UNITED STATES PATENT AND TRADEMARK OFFICE

APPLICATION NO.	FILING DATE	FIRST NAMED INVENTOR	ATTORNEY DOCKET NO.	CONFIRMATION NO.
10/718,221	11/20/2003	Kim Seah Goh	303798 46623	9025

Office Action Summary	Application No. 10/718,221	Applicant(s) GOH, KIM SEAH	
	Examiner Christopher D. Koharski	Art Unit 3763

DETAILED ACTION

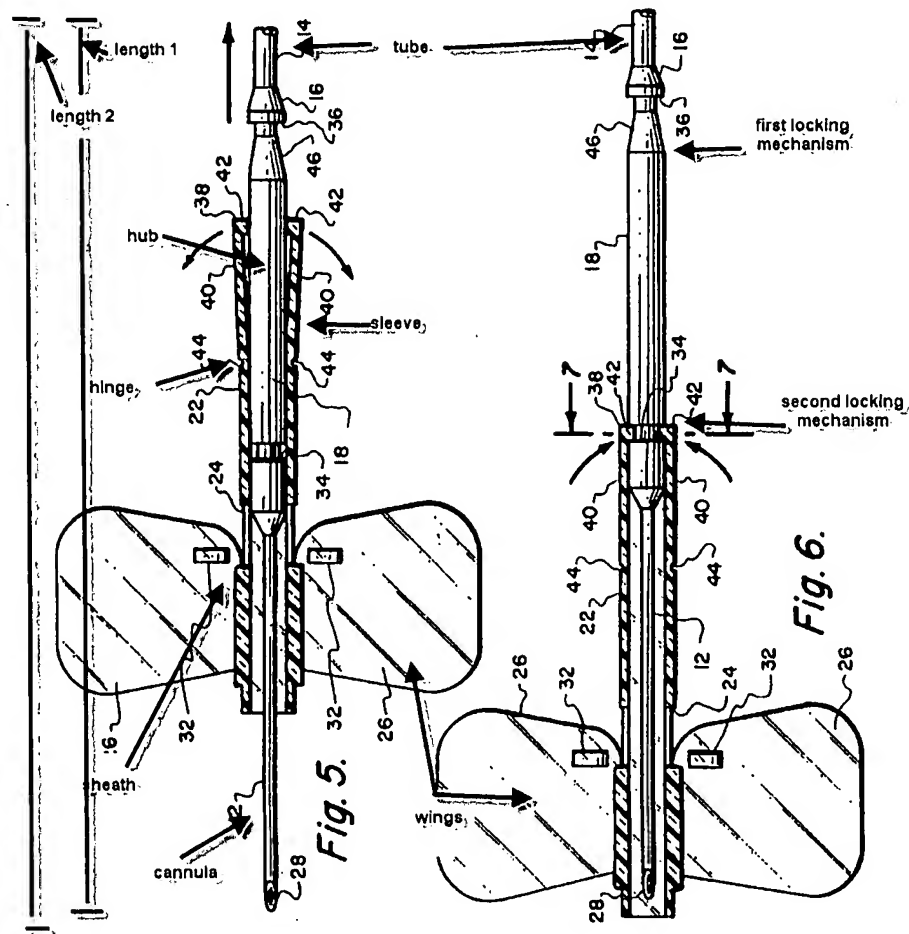
Regarding claims 1-2, 5, 10-12, 18-22, 25, 28 and 30, Lam discloses a telescopic winged safety needle assembly, comprising a hub (20) having a distal end, a proximal end (Figure 4), and an axial hole therethrough, a rotatable cannula (12) joined to said hub adjacent the distal end of the hub, a cylindrical sleeve (element covering 18, closest to 40) having a locking tab (near 42) attached thereto by a hinge (44), said cylindrical sleeve being axially disposed on said hub (Figures 5-6), a cylindrical sheath (see marked up drawing below, near 24) for retaining said hub therein and having a distal end and a proximal end, said hub being slidable along an interior surface of said cylindrical sleeve and sheath (emphasis added) (see Figures 5-6) from a first telescopic position (Figure 5) at which the distal end of said cannula joined to said hub projects beyond the distal end of the cylindrical sheath by a predetermined length, to a second position which is maximized in length (Figure 6) at which the distal end on the cannula is protectively covered within said cylindrical sheath, with said cylindrical sleeve being axially disposed on said proximal end of said cylindrical sheath (see Figures 1-6 and marked up drawing below), a pair of flexible wings (26) provided on the outer peripheral surface adjacent the distal end of said cylindrical sheath, a first and second locking mechanism comprising tabs and grooves, (near 46, 34) disposed on said assembly whereby the first locking mechanism releasably locks said hub, said sleeve and said sheath at the first position and a second locking mechanism that unreleasably lock said

hub, sleeve and sheath at the second position, with a tube (14) being attached to the proximal end of the hub (see Figures 1-6 and marked up drawing below).

Applicant's arguments filed 2/28/2007 have been fully considered but they are not persuasive. Applicant's Representative asserts that the Lam reference does not show the elements of the hub, sleeve, and sheath with the hub being slidable along an inner surface of said sheath and an inner surface of said sleeve. In Applicant's arguments, Applicant Representative summarily dismissed the Examiners rejection by examining the patent reference terms and not Examiner's interpretation of the reference and the claims of the application at hand. Examiner has included a marked up drawing of the specific elements in question, and the interpretation thereof. As shown in the drawings and highlighted in the rejection above the reference clearly shows the elements argued in their respective positions as currently claimed by Applicant, of specific note the sleeve being axially disposed on said proximal end of said cylindrical sheath and the assembly being maximized in length at a second telescopic position as indicated in the marked up drawings by the different associated lengths.
